**Re: Lot 2 Block 2 Unit 27 Volcano Cliffs SAD 228
5504 Valiente NW
Request Permanent C.O. – Accepted
Engineer's Stamp dated: 4-23-2020 (C11D006)
Pad Certification dated: 6/23/2020
Certificate of C.O. dated: 2/22/2021**

Based on the Certification received on 2/23/2021, the site is acceptable for release of Certificate of Occupancy by Hydrology.

ENGINEER'S SEAL	LOT 2 BLK 2 UN 27 VOLCANO CLIFFS 5504 VALIENTE ROAD NW	DRAWN BY DEM
DAVID SOULE NEW MEXICO 14522 REGISTERED PROFESSIONAL ENGINEER	GRADING AND DRAINAGE PLAN	DATE 4-18-20
4/23/20	Rio Grande Engineering 1606 CENTRAL AVENUE SE SUITE 201 ALBUQUERQUE, NM 87106 (505) 872-0999	Let 2 Blk 2 Un 27 VOLCANO CLIFFS.DWG
DAVID SOULE P.E. #14522		SHEET # C1
		JOB #

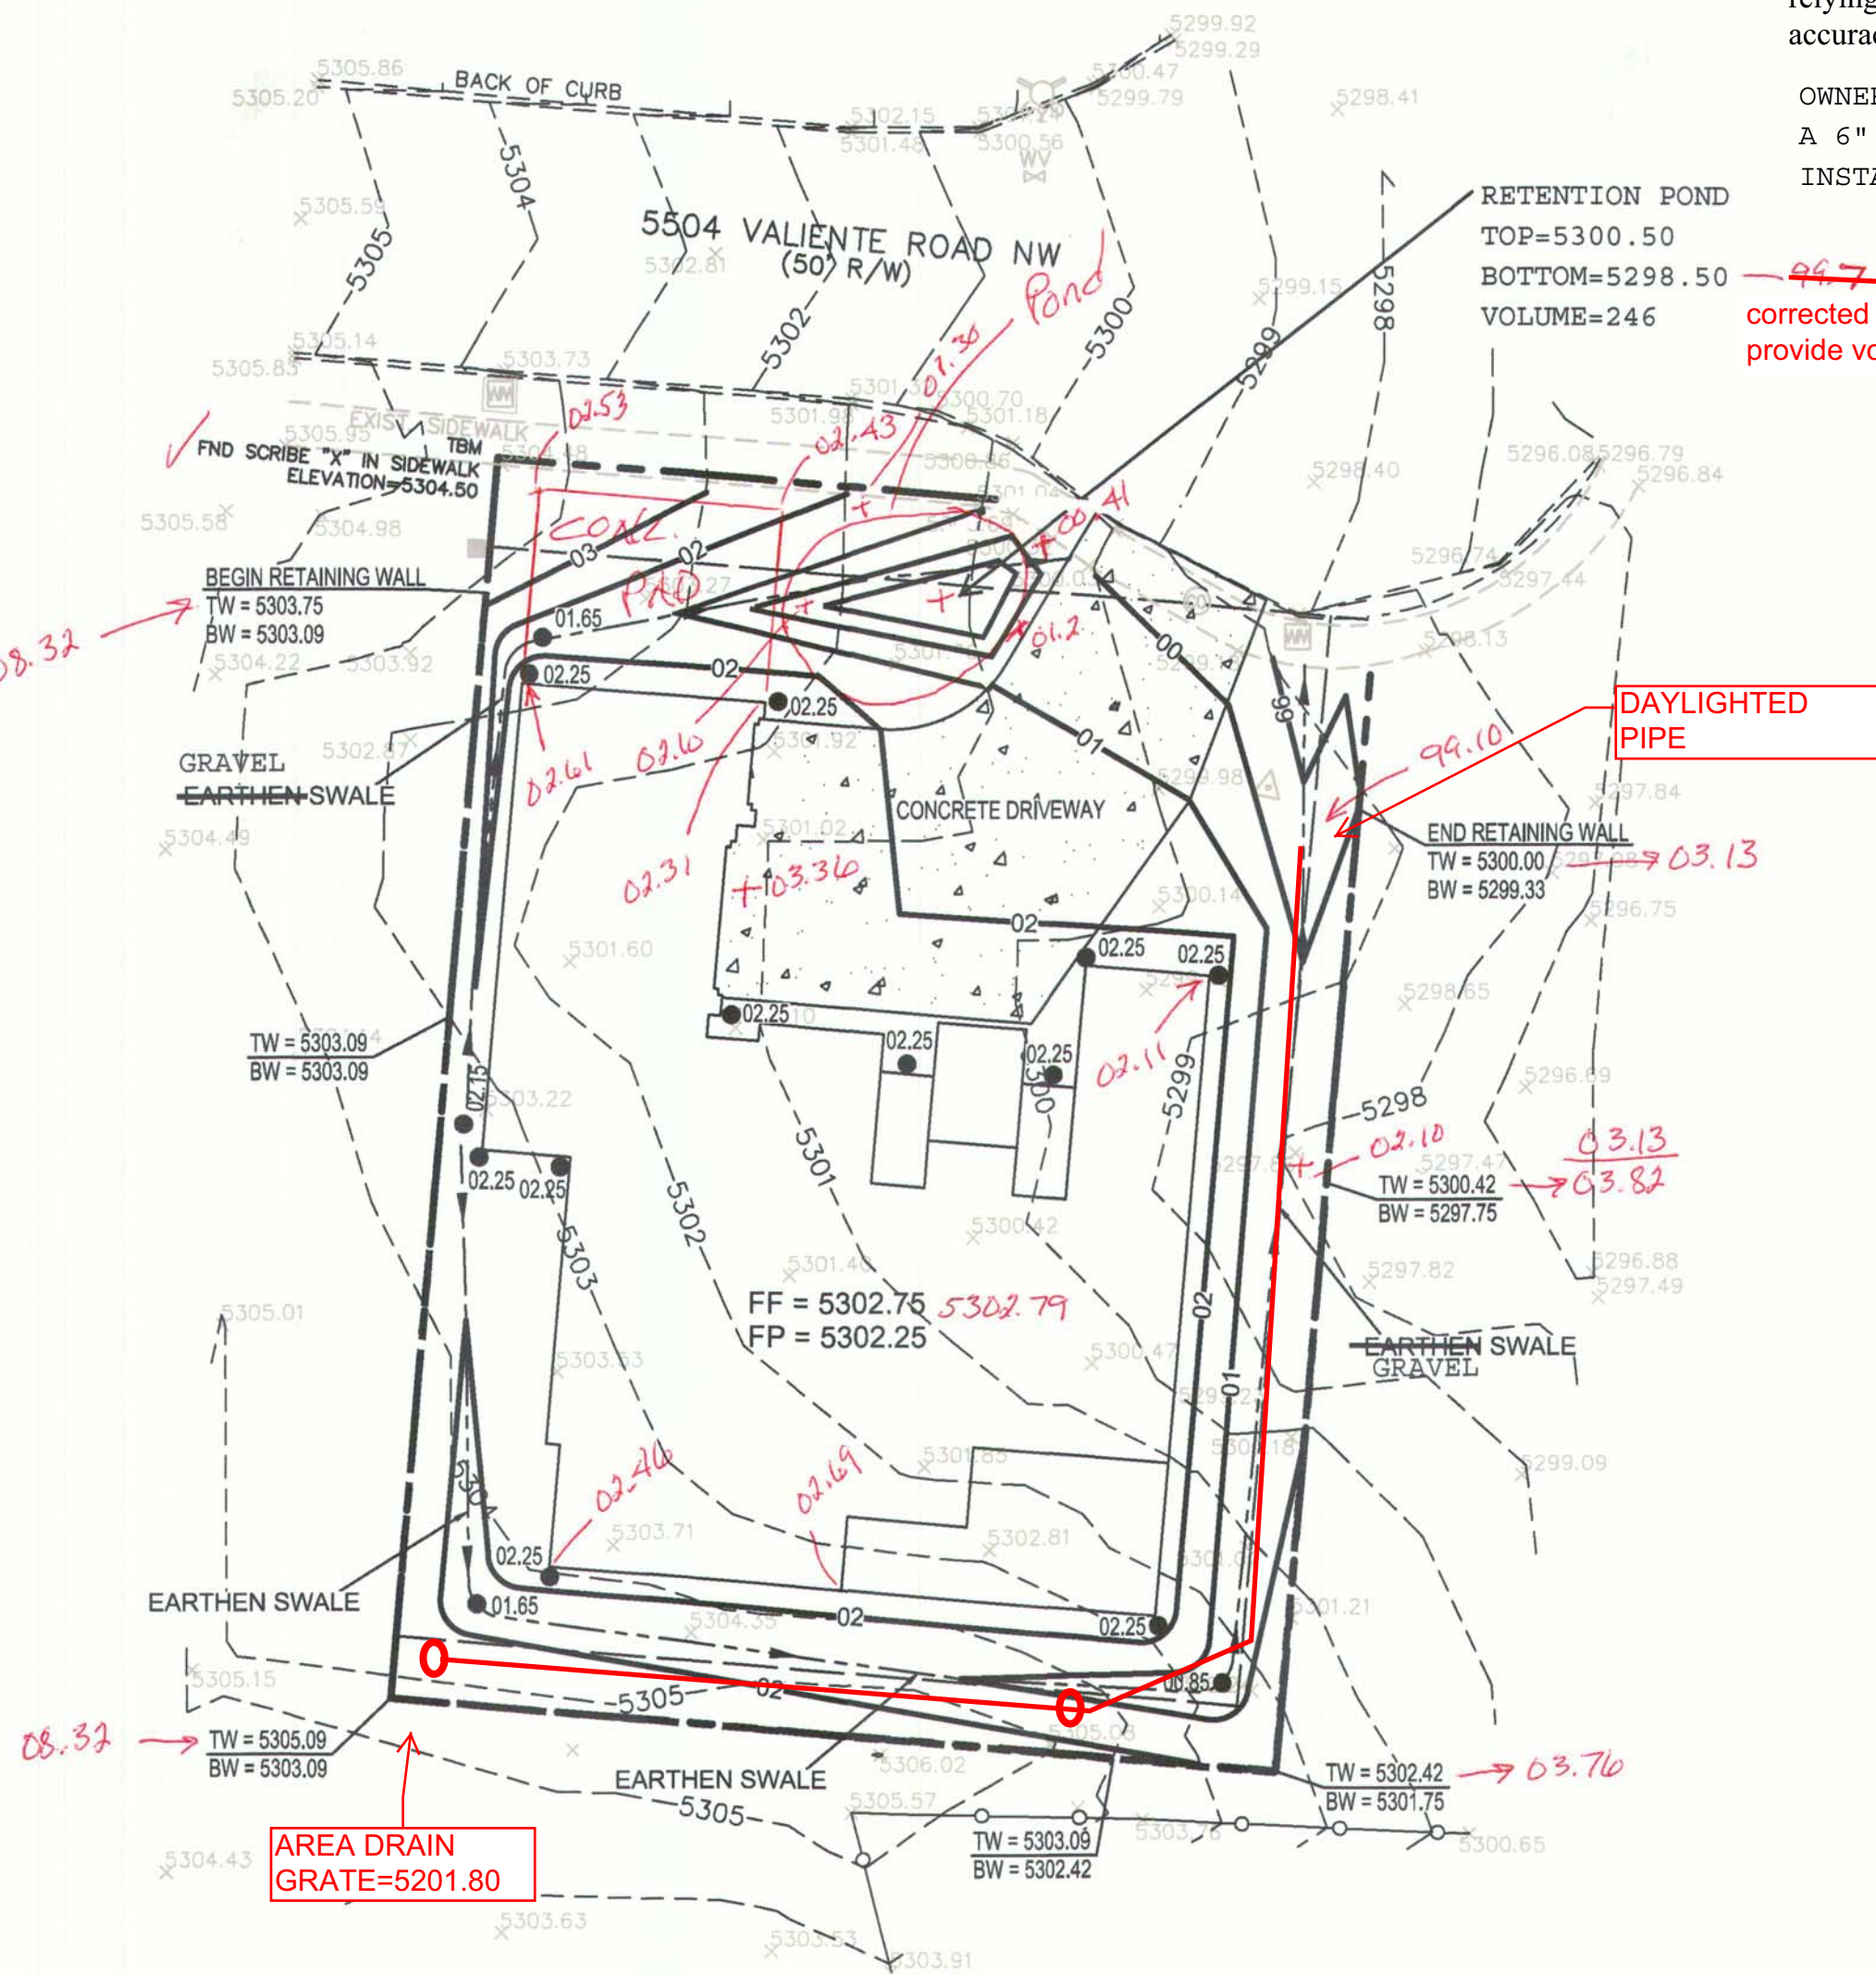
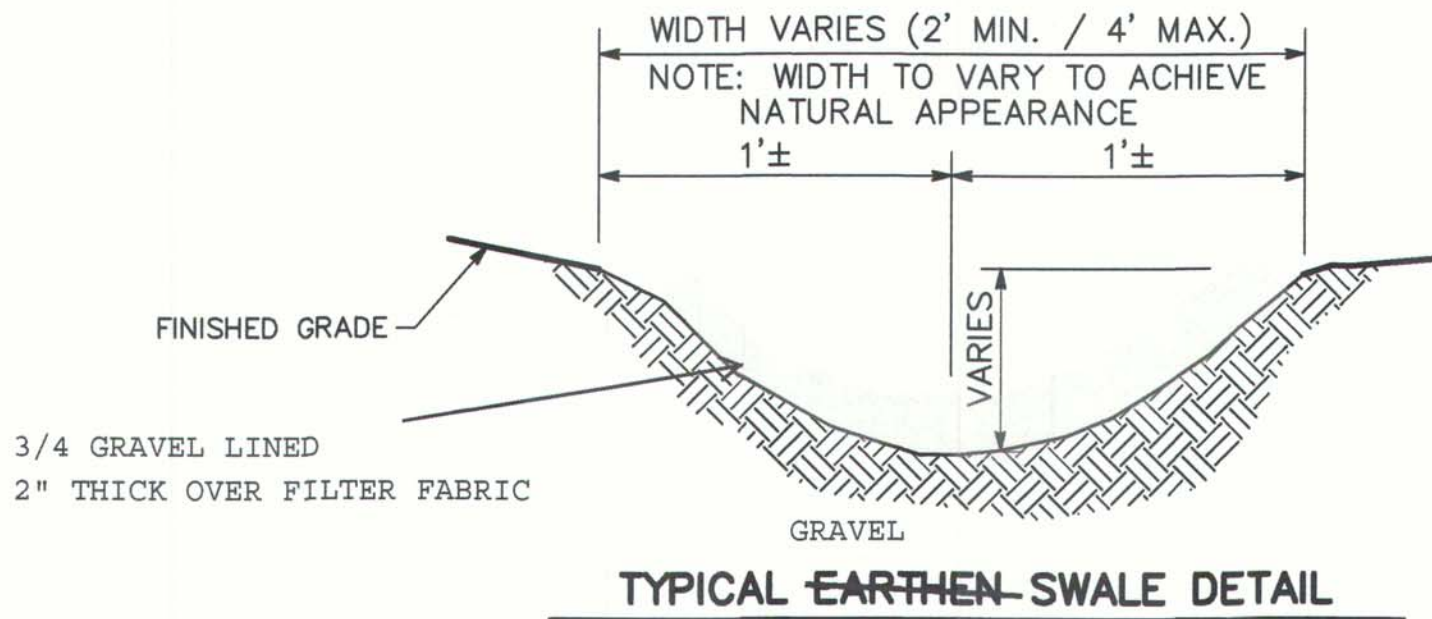
OWNER INSTALLED BASKETBALL COURT FORCING FLOWS TO REAR.
A 6" PVC STORM DRAIN SYSTEM WITH TWO AREA DRAINS WERE INSTALLED TO CONVEY REAR YARD WATER TO FRONT
